49 CFR Parts 571

[Docket No. NHTSA 2005–22052]

Federal Motor Vehicle Safety Standards; Seat Belt Assemblies

ACTION: Final rule.

Figure 8: Acceleration Corridors

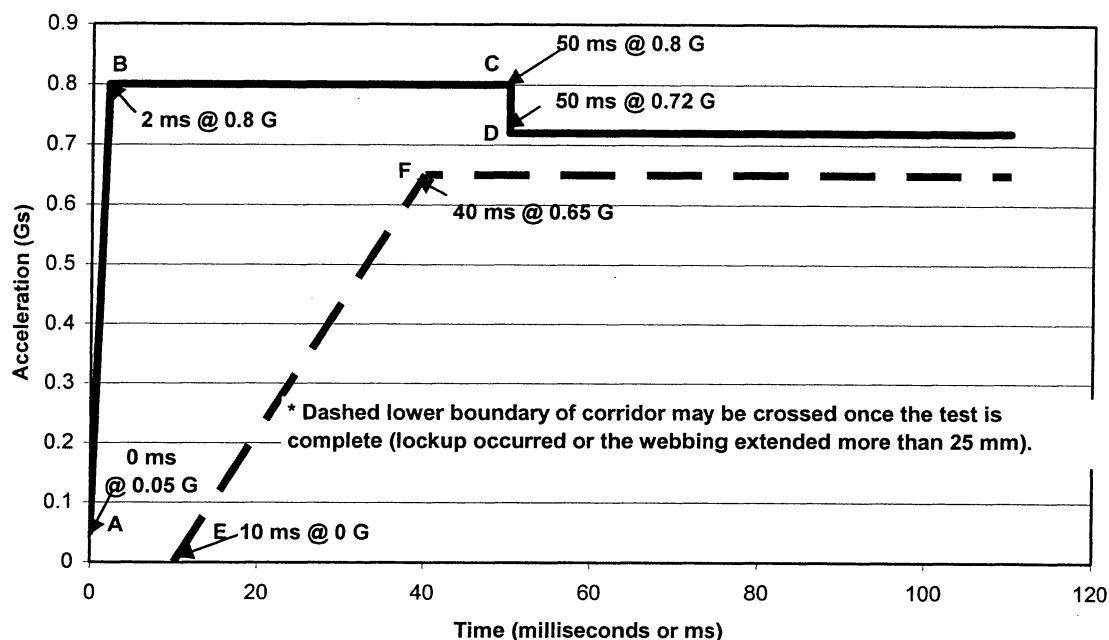
A number of commenters raised concerns about the proposed A-T corridor, including the AORC, TK Holdings, Ford, and Dr. Ziv. The AORC commented that the NPRM's expansion of the A-T corridor beyond the boundaries originally recommended in its petition for rulemaking is unnecessary. Specifically, the AORC objected to the NPRM's proposed lower onset rate, because the AORC believes that static friction in the ELR, coupled with the low onset rate, could result in nuisance locking during routine driving.

To address its concern, the AORC developed a new lower A-T corridor as part of its comment submission, which reflects a compromise between the AORC's original suggested boundary and the one proposed in the NPRM. (TK Holdings supported such a compromise approach in its comments.)

Regarding the upper boundary of the proposed A-T corridor, commenters expressed divergent viewpoints. TK Holdings concurred with the upper boundary presented in the NPRM. However, the AORC objected to the high onset rate (*i.e.*, 375 g/sec). Although the AORC acknowledged that high onset rates do occur during high-speed barrier crashes, it argued that these tests serve the purpose of demonstrating performance under these conditions, so no component-level test is necessary. In addition, the AORC argued that it does not know of any commercially-available, component-level test equipment that can reliably conduct a test with an onset rate above 200 g/sec. As an alternative, the AORC developed and submitted a new upper corridor, which: (1) Adopts the agency's upper corridor limit of 0.8 g; (2) modifies the limit along the "sustain" portion at the end of the test to 0.75 g (*i.e.*, the portion of the A-T corridor in which the steady-state response should have been achieved), and (3) provides a maximum onset rate of 150 g/sec.

TK Holdings expressed concern about the range of the corridor after 50 ms, arguing that the boundary should be controlled such that 0.7 g is at the center of the upper and lower limit of the corridor. Accordingly, TK Holdings recommended a range of $0.7 \text{ g} \pm 0.05 \text{ g}$ for the corridor after 50 ms.

Ford commented that the NPRM's proposed A-T corridor is not objective because it is overly broad and that other concerns about test objectivity have not been adequately addressed. For example, Ford expressed concern that an agency contracting laboratory could choose an audit test pulse that is substantially different from the pulse

In his comments, Dr. Ziv sought clarification as to whether a retractor must meet the requirements for any acceleration pulse within the proposed corridor, or at least one acceleration pulse within the corridor.

In response to these comments, the agency has decided to modify the lower boundary of the A-T corridor in the manner suggested by the AORC in its latest submission. NHTSA's intention in proposing the lower boundary in the NPRM was to ensure that it encompassed current test pulses, particularly those with slower onset rates. Although the AORC did not provide any data to demonstrate the nature and extent of this "nuisance locking" problem, we believe that the AORC's proposed new lower boundary would address the concern of potential "nuisance locking," while maintaining inclusion of all current test pulses. In addition, we believe that the new lower A-T corridor should minimize the variation in onset rates, while maintaining the repeatability and reproducibility of the test procedures.

Regarding comments on the upper corridor boundary, the agency has decided to adopt, as part of this final rule, the same upper corridor boundary that was presented in the NPRM. High onset rates do occur in crashes, and even though current equipment cannot generate pulses of that magnitude, technological developments may permit generation of such pulses in the future. The agency believes that a high onset rate limit is not detrimental to current ELR performance or vehicle safety. Instead, we believe that it is advantageous for manufacturers to reach 0.7 g in the shortest time period possible, because that would make the maximum amount of webbing payout available to achieve compliance. In addition, we believe that the specificity in the final rule's data acquisition methodology (discussed below) will prevent the generation of unreliable test pulses with overly-high onset rates.

recommended change. In addition, the AORC did not provide evidence to demonstrate a compliance problem with its test pulses to meet a steady-state tolerance between 0.65 g and 0.72 g, as would justify its request to change the upper limit on the "sustain" portion of the boundary to 0.75 g; all test pulses included in the AORC's comments fell within the proposed tolerance, and the pulses generated by the agency during compliance testing similarly fell within that range.

In response to Dr. Ziv's comment, we would clarify that the ELR must meet the standard's requirements for any and all acceleration pulses that could be generated within the A-T corridor. Otherwise, proper functioning of the ELR could be limited to a highly targeted subset of the conceivable test pulses than would otherwise occur in actual crash events.

The agency notes that in this final rule, we have modified the lower boundary of the A-T corridor such that the initial peak must be obtained within 40 ms. However, we do not believe that this modification will impact any existing compliant ELR because agency data show that current acceleration pulses reach 0.7 g well before 40 ms.
